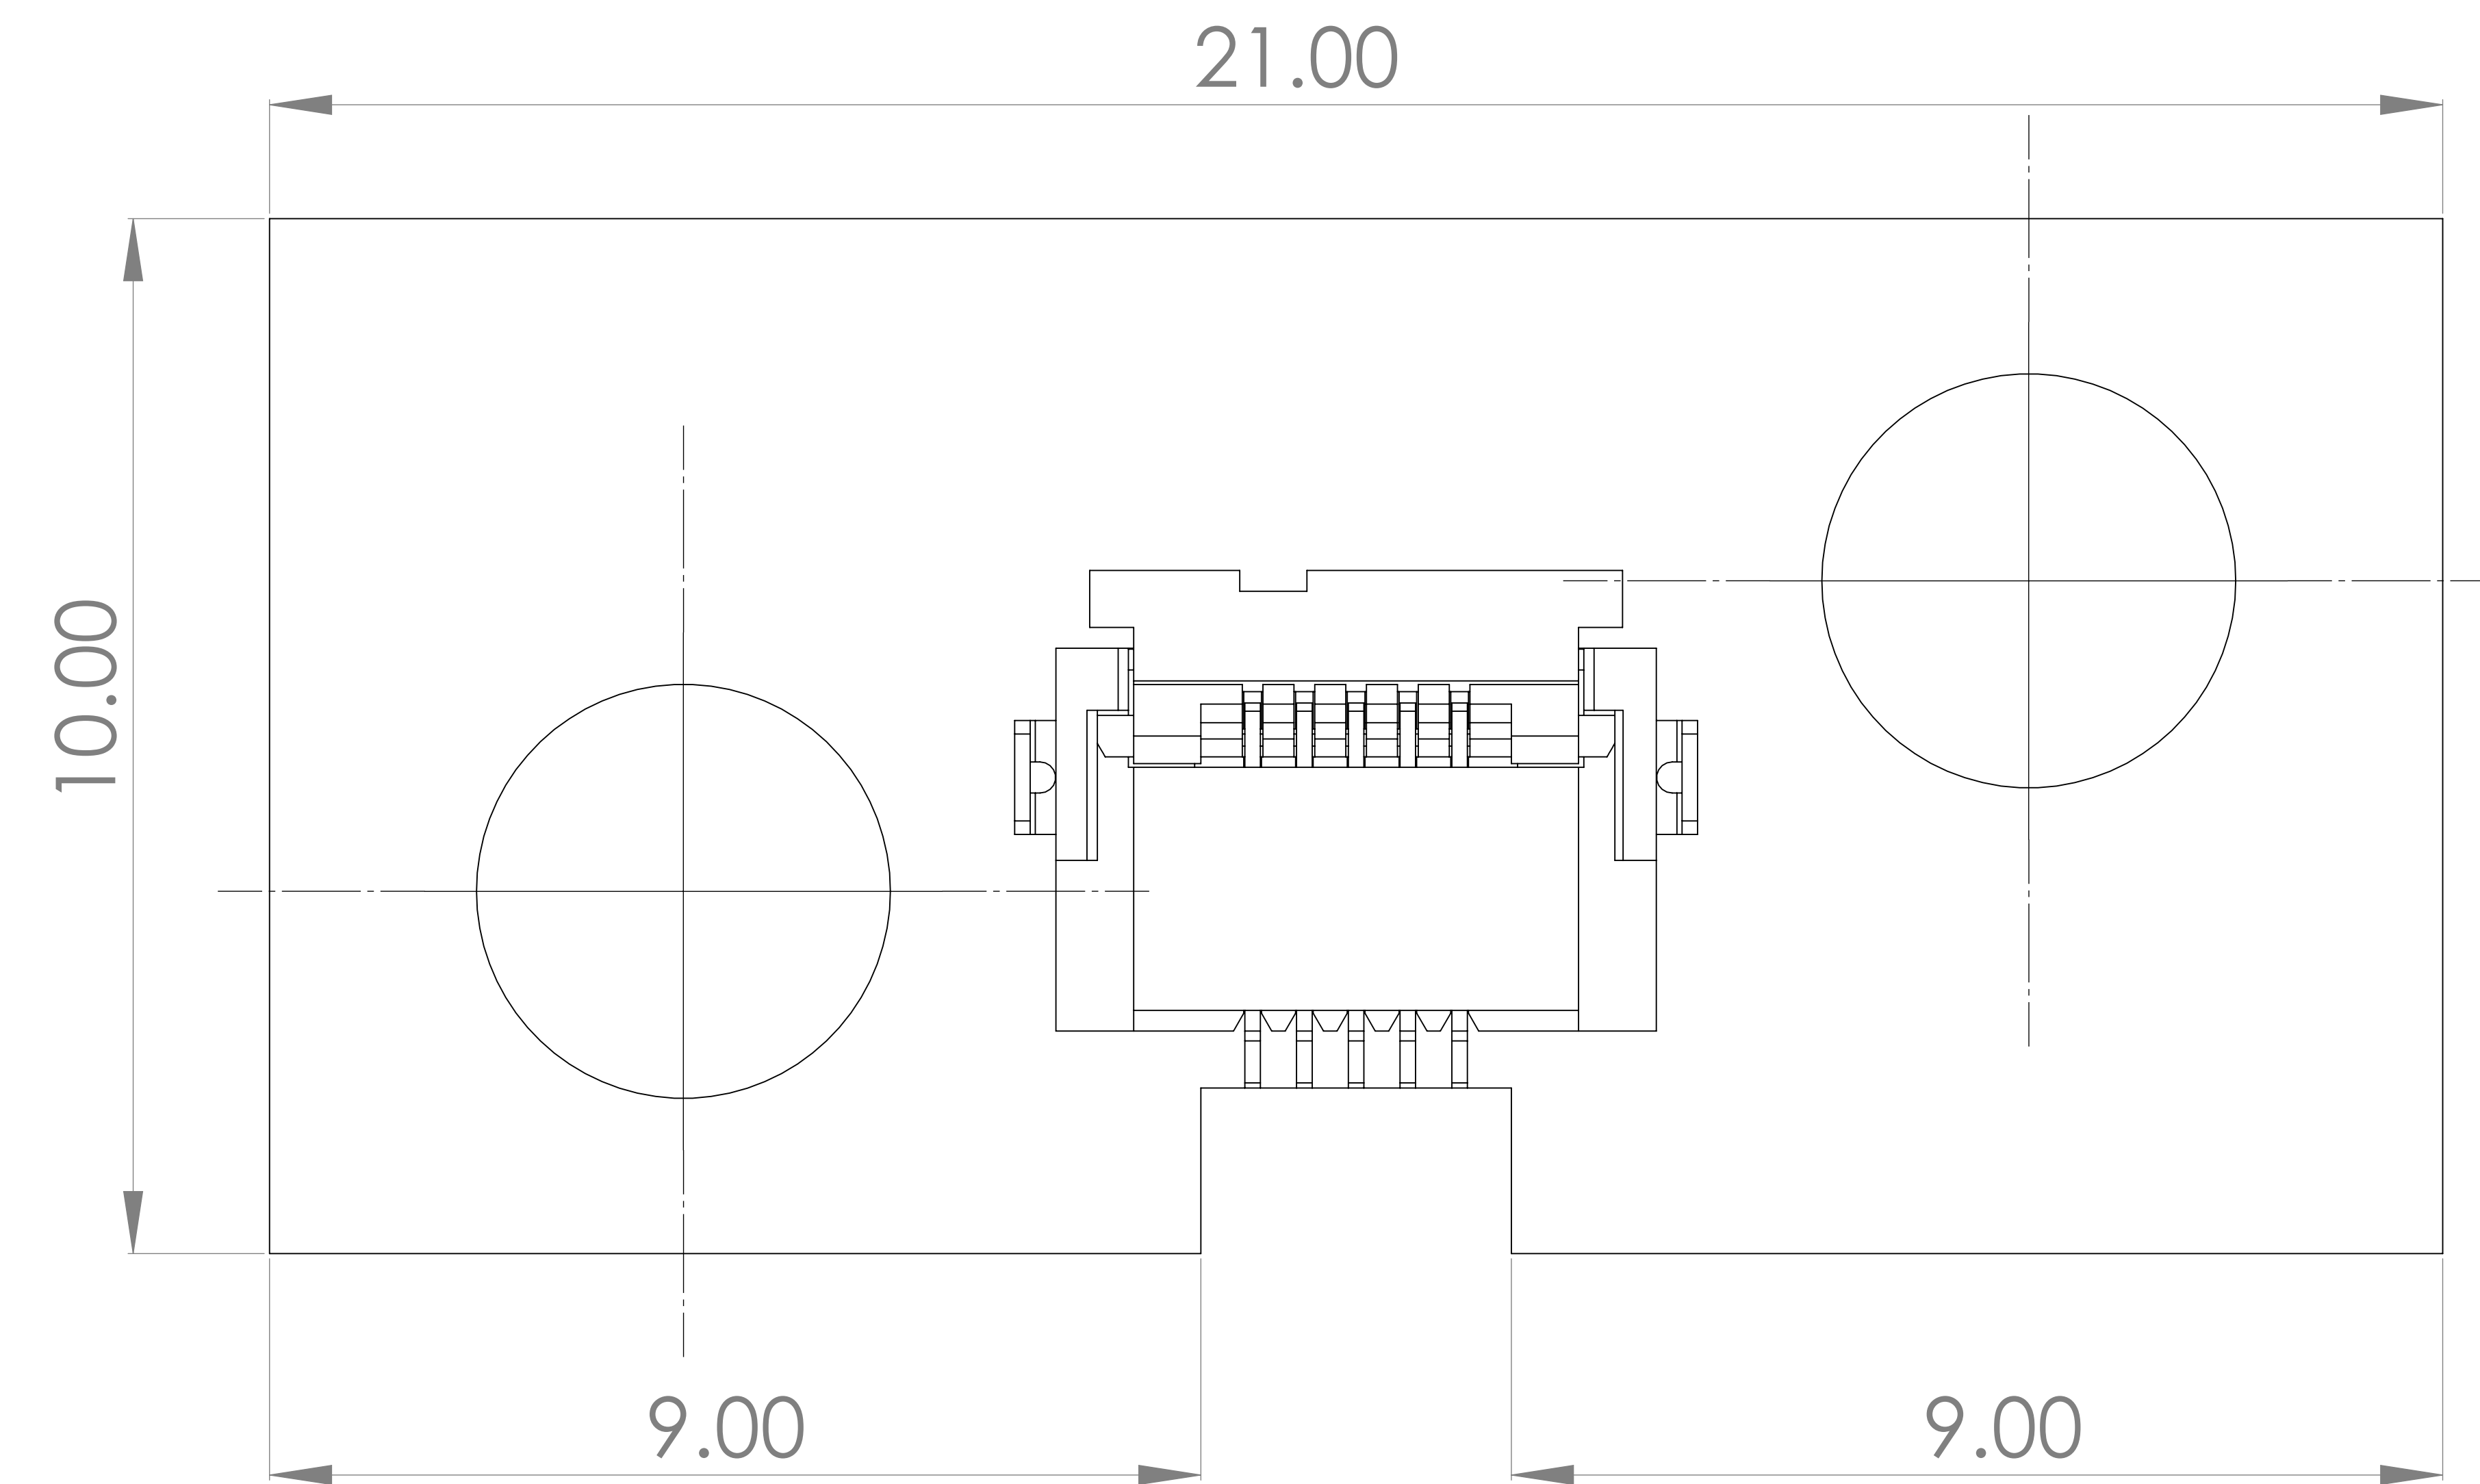
LED needs to move down ~1mm on the PCB

Connector needs to move up on the PCB so as not to interfere with the cut out
